Access Compliance Report

Public Rights-of-Way

Intersection ID: 28526	Main Street: ROLLINGBROOK_DR	Cross Street: TYVOLA_CENTRE_DR	Location: NW
ADA ID: 63E41C95E9CF	Ramp Type: Directional1	Initial Pass/Fail: Pass	Overall Compliance: No
		Severity Score: 0

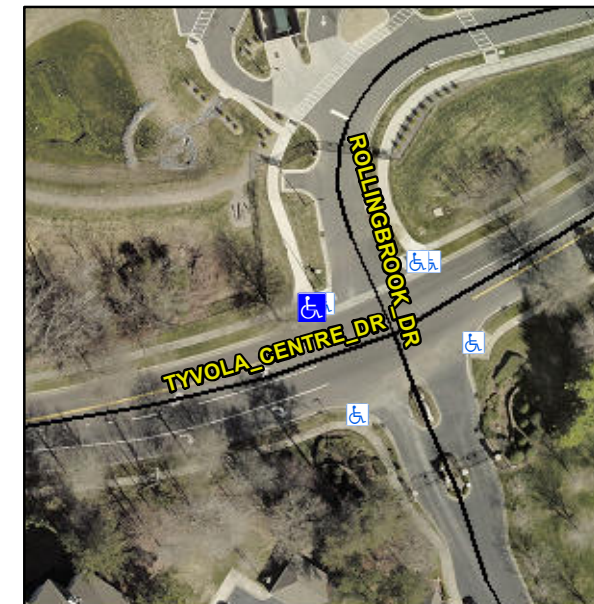
R304.5.2

Compliance	Description	Data	Compliance	Description	Data
N/A	Ramp Length (in)	75.0	No	Grade Break?	No
Yes	Ramp Width (in)	53.0	N/A	Grade Break Slope (%)	N/A
Yes	Ramp Slope (%)	7.6	N/A	Grade Break XSlope (%)	N/A
Yes	Ramp XSlope (%)	1.3			
N/A	Flare Type LT	N/A	N/A	Flare Type RT	N/A
N/A	Flare Slope LT (%)	N/A	N/A	Flare Slope RT (%)	N/A
N/A	Flare Traversable LT?	N/A	N/A	Flare Traversable RT?	N/A
Yes	Landing Length (in)	48.0	Yes	DWS Provided?	Yes
Yes	Landing Width (in)	61.0	Yes	DWS Contrast?	Yes
Yes	Landing Slope (%)	0.8	Yes	DWS Length (in)	24.0
Yes	Landing X Slope (%)	1.4	Yes	DWS Full Width?	Yes
N/A	Landing Curb? (Y/N)	N/A	Yes	DWS Offset LT (in)	22.0
N/A	Shared Landing?	Yes	Yes	DWS Offset RT (in)	1.0
Yes	Gutter Ponding?	No	Yes	Gutter Slope (%)	2.5
Yes	Gutter Lip Ht (in)	0.0	Yes	Gutter X Slope (%)	1.0
N/A	Painted X Walk1?	No		Road Slope (%)	5.4
	X Walk 1 Direction	To S		Road X Slope (%)	2.2
	X Walk 1 Width (in)	N/A		Clear Space?	Yes

Remove & Replace Entire Ramp.
